**From:** Brad Harvey  
**Sent:** Friday, August 22, 2008 4:26 PM  
**To:** Ramsdell, James V Jr (Van)  
**Cc:** Paul Kallan; Raj Anand; Charles Cox; STPCOL  
**Subject:** STP SACTI Runs  
**Attachments:** RAI Letter\_06262008.pdf

June 26, 2008  
ABR-AE-08000046

South Texas Project  
Units 3 and 4  
Docket Nos. 52-012 and 52-013  
Response to Requests for Additional Information

**FIGURE 1 Palacios Annual Wind Rose**

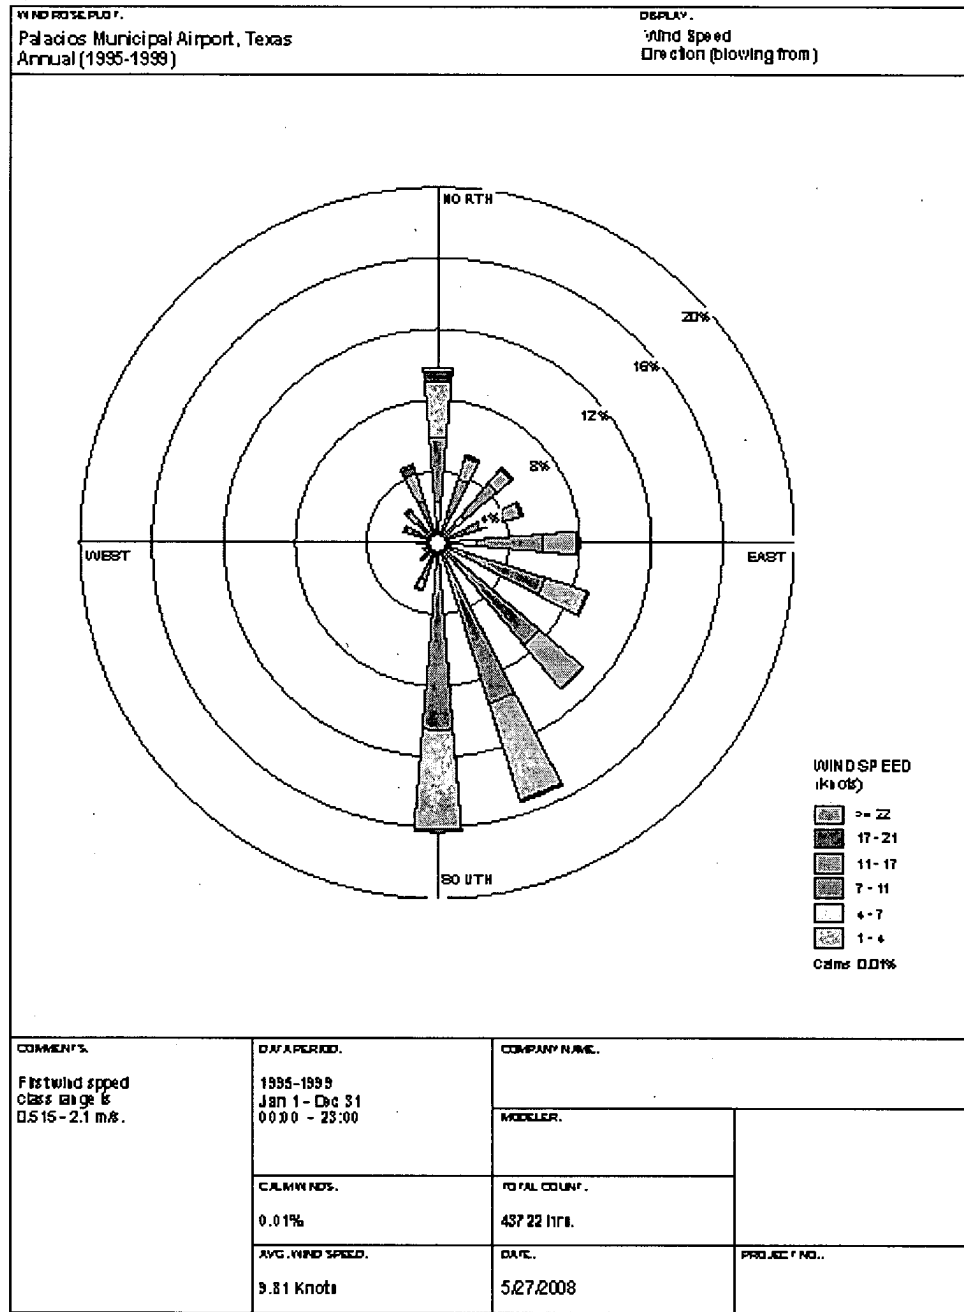
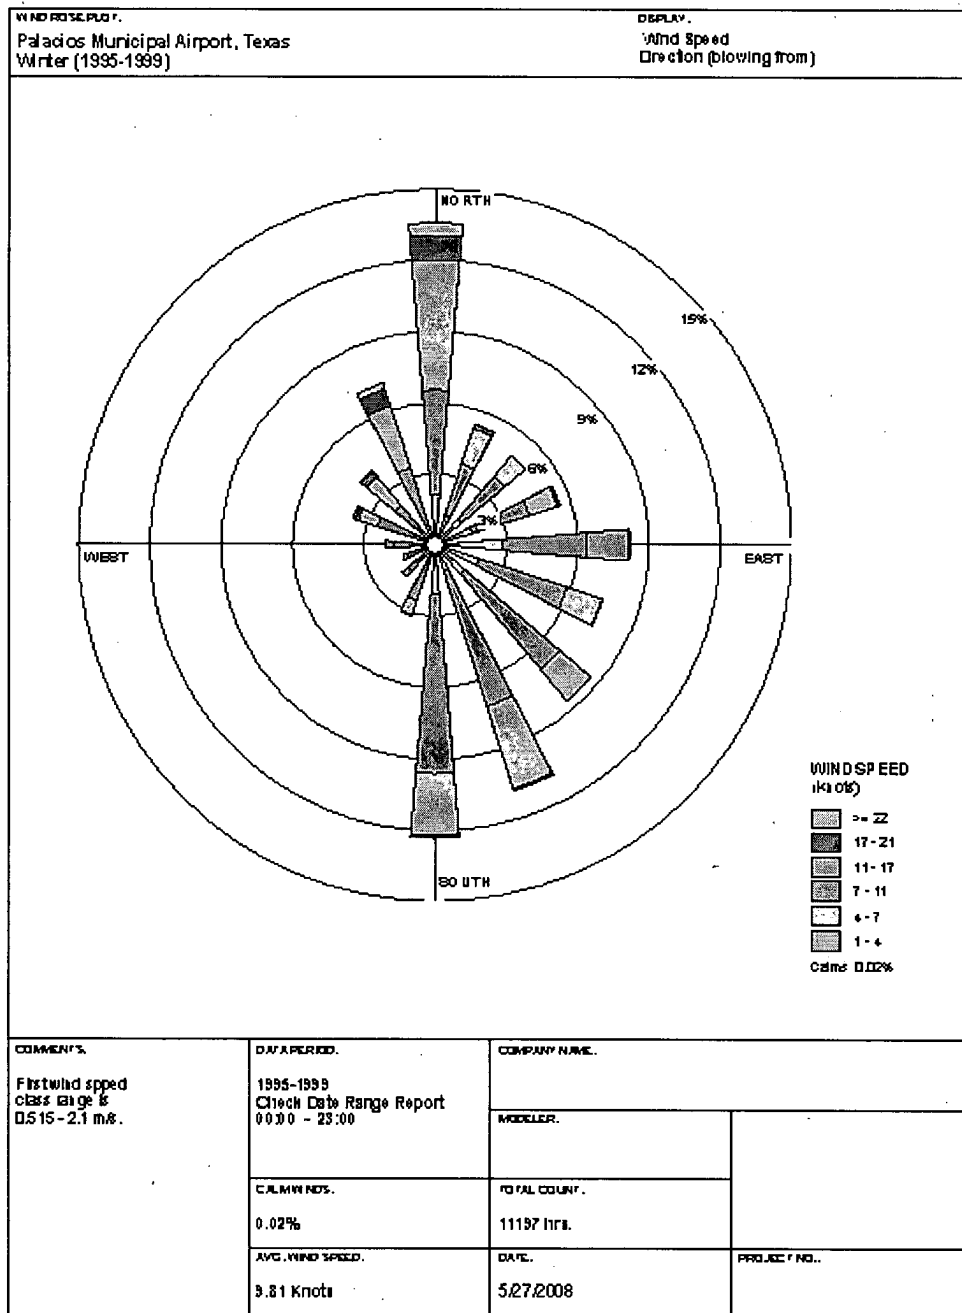
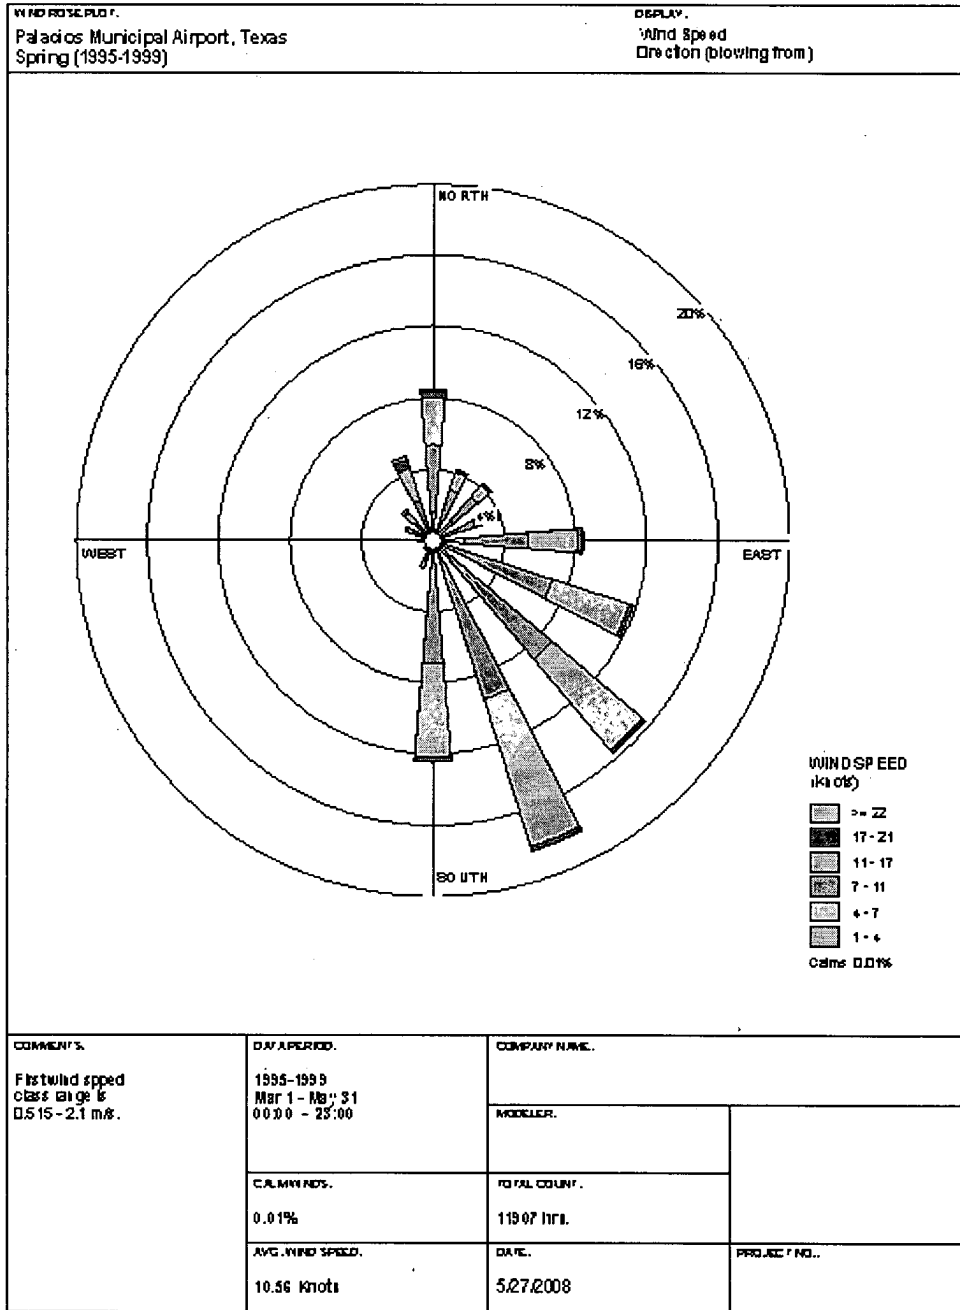
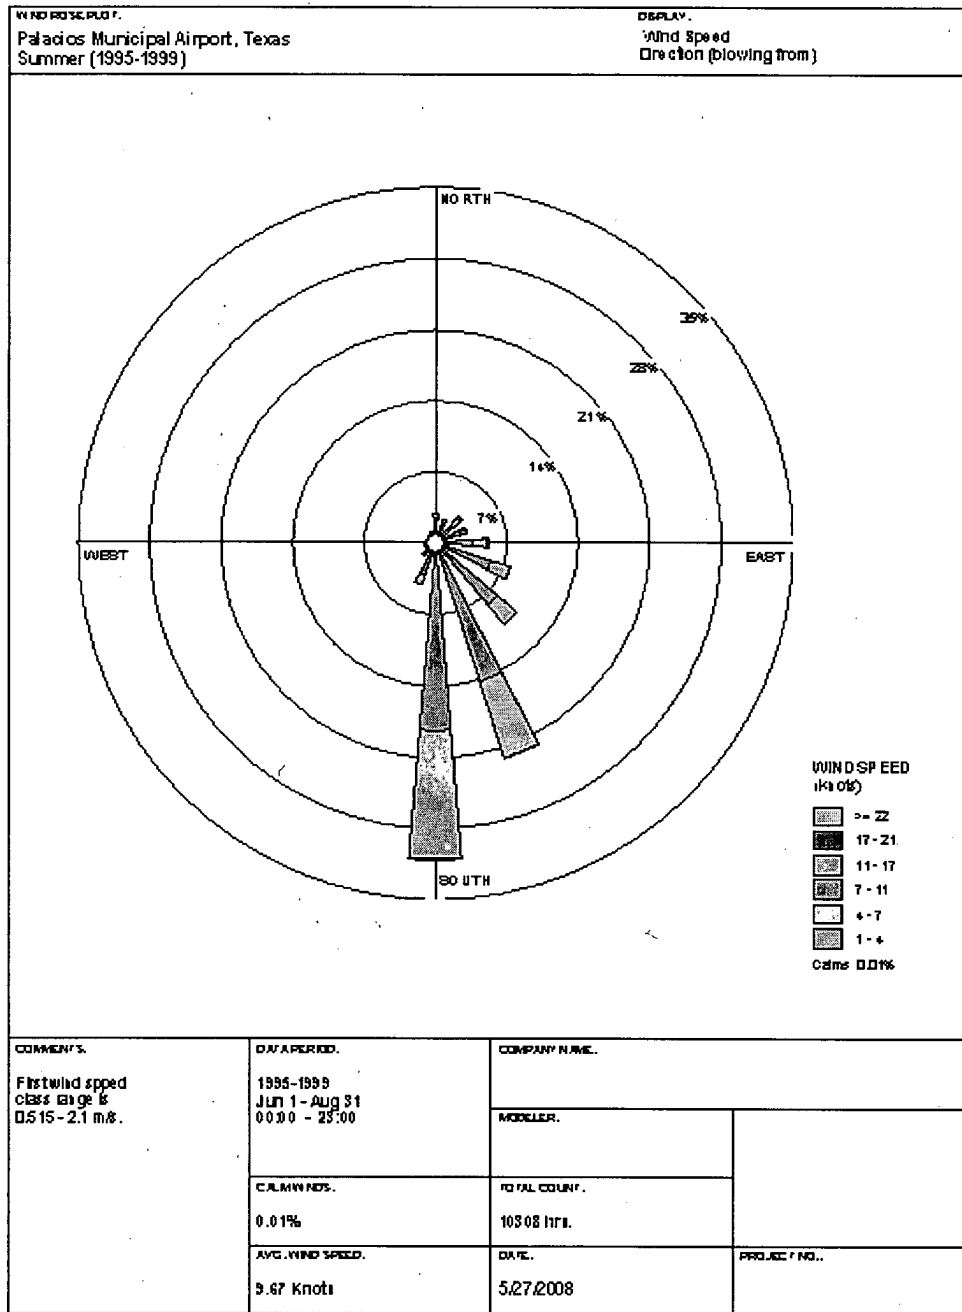
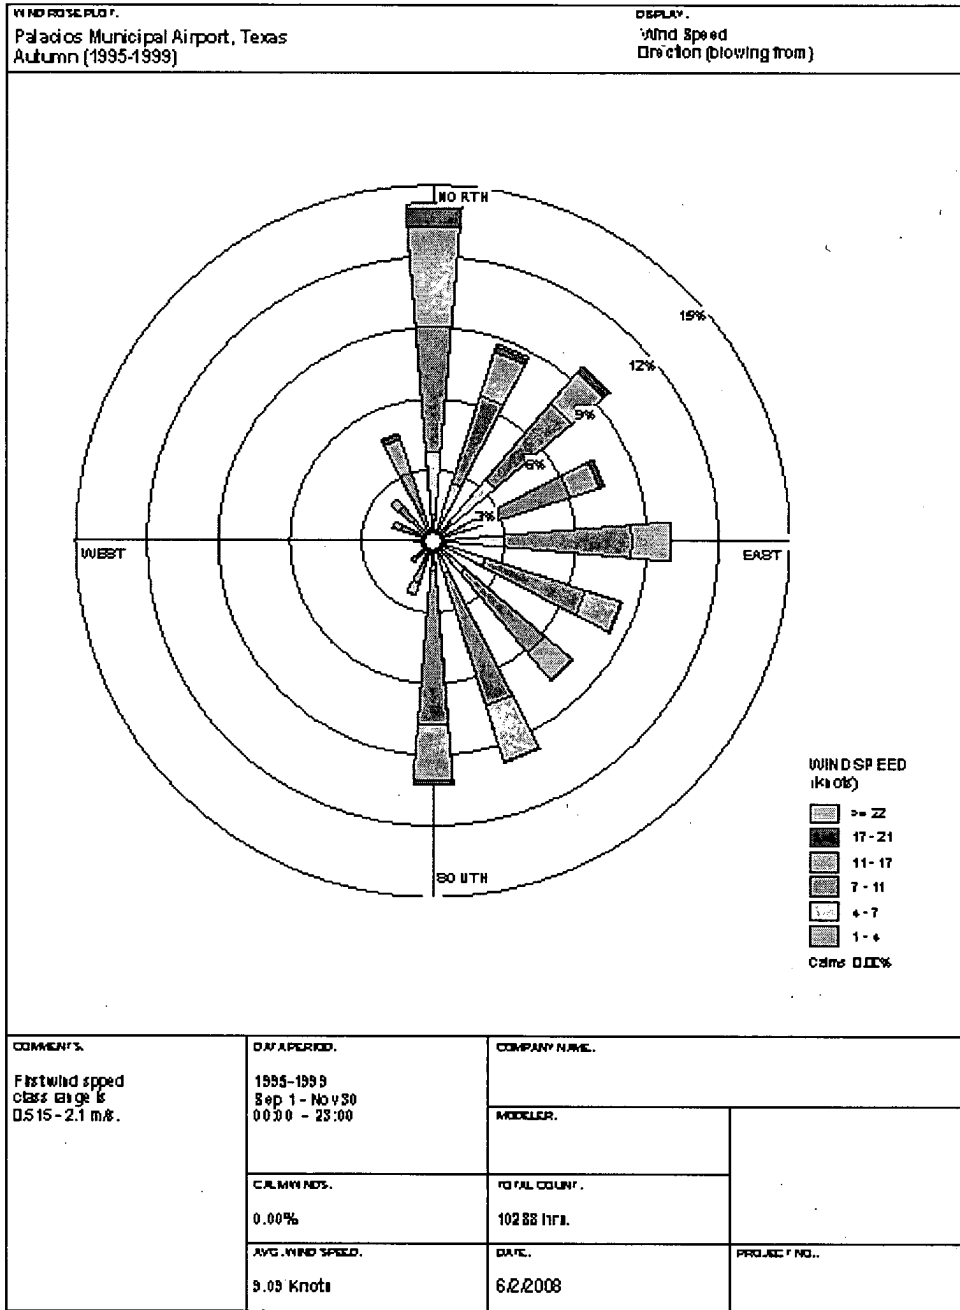
(a) A 5-year period (i.e., 1995 through 1999) of wind measurements from the cooperative observing station at the Palacios Municipal Airport (Reference 1) has been evaluated. Longstanding U.S. EPA guidance has determined that for dispersion-related analyses, variations over a 5-year period of record are representative of longer duration data sets. Wind roses based on this data set for Palacios (Figures 1 through 5) show reasonably similar characteristics in predominant directions on an annual basis when compared to the onsite annual wind rose (see Figure 2.3S-2) (i.e., from the southeast through south sectors) and as indicated in the 2005 Local Climatological Data (LCD) summary for the Victoria National Weather Service (NWS) station (see Table 2.3S-2) (i.e., a prevailing direction of 160° or from the south-southeast sector).

Specific differences in directional frequencies and mean wind speeds may be due to station siting and instrumentation, and to different periods of record among the three stations. Nevertheless, the wind direction and wind speed data show reasonable intermediate-field (Palacios) and far-field (Victoria) similarity to the wind conditions measured at the STP site.

Based on the 5-year period of record from 1995 through 1999, wind direction measurements from the cooperative observing station at the Palacios Municipal Airport (Reference 2.3S-27) show reasonably similar characteristics in predominant directions on an annual basis. At both locations, reasonably similar variations in the predominant wind direction sectors over the course of the year are also evident.
